Final Product/Process Change Notification

Document #:FPCN22686Z1

Title of Change:	Update to FPCN22686Z with reference to CASE 507AU issue A in the previous announced Through Slot Wettable Flank Solution for PQFN56 Punch Automotive.	
Proposed Changed Material First Ship Date:	16 Apr 2020 or earlier if approved by customer	
Current Material Last Order Date:	01 Jan 2020 <i>Orders received after the Current Material Last Order Date expiration are to be considered as orders for new changed material as described in this PCN. Orders for current (unchanged) material after this date will be per mutual agreement and current material inventory availability.</i>	
Current Material Last Delivery Date:	15 Apr 2020 <i>The Current Material Last Delivery Date may be subject to change based on build and depletion of the current (unchanged) material inventory</i>	
Product Category:	Active components – Discrete components	
Contact information:	Contact your local onsemi Sales Office or Peter.Lee@onsemi.com

BOTTOM VIEW

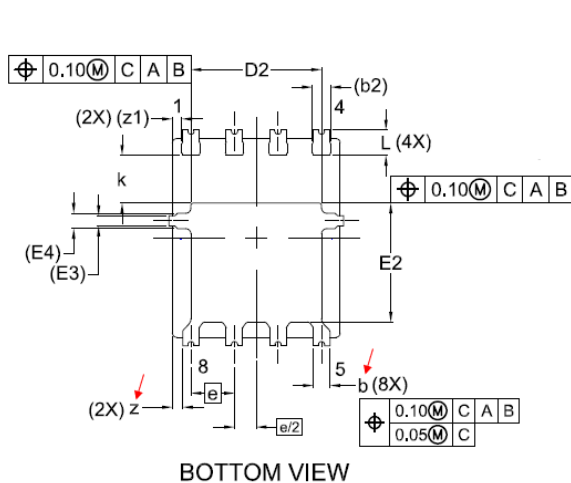
Change Category		
Category	Type of Change	
Process - Assembly	Change in leadframe dimensions	
Description and Purpose:		
Update to FPCN22686Z with reference to CASE 507AU issue A in the previous announced Through Slot Wettable Flank Solution for PQFN56 Punch Automotive.		
	From	To
LeadFrame	<u>Through Slot Wettable Flank</u> Dimension b: 0.49 ± 0.05 mm (lead width) Dimension z: 0.30 ± 0.05 mm (lead to package edge distance)	<u>Through Slot Wettable Flank</u> Dimension b: 0.52 ± 0.05mm Dimension z: 0.29 ± 0.05mm
Case outline dimensions that is affected by the change is highl ighted in Red color:

DIM	CASE 507AU Issue O			CASE 507AU Issue A		
	MIN	NOM	MAX	MIN	NOM	MAX
A	0.90	1.00	1.10	0.90	1.00	1.10
A1	0.00	-	0.05	0.00	-	0.05
A2	0.65	0.75	0.85	0.65	0.75	0.85
A3	0.30 REF			0.30 REF		
b	0.44	0.49	0.54	0.47	0.52	0.57
b1	0.13	0.18	0.23	0.13	0.18	0.23
b2	0.54			0.54		
D	5.00	5.10	5.20	5.00	5.10	5.20
D1	4.80	4.90	5.00	4.80	4.90	5.00
D2	3.72	3.82	3.92	3.72	3.82	3.92
E	6.20	6.30	6.40	6.20	6.30	6.40
E1	5.70	5.80	5.90	5.70	5.80	5.90
E2	3.38	3.48	3.58	3.38	3.48	3.58
E3	0.30 REF			0.30 REF		
E4	0.45 REF			0.45 REF		
e	1.27 BSC			1.27 BSC		
e/2	0.635 BSC			0.635 BSC		
k	1.30	1.40	1.50	1.30	1.40	1.50
L	0.64	0.74	0.84	0.64	0.74	0.84
z	0.25	0.30	0.35	0.24	0.29	0.34
z1	(0.28)			(0.28)		
θ	0°	---	12°	0°	---	12°
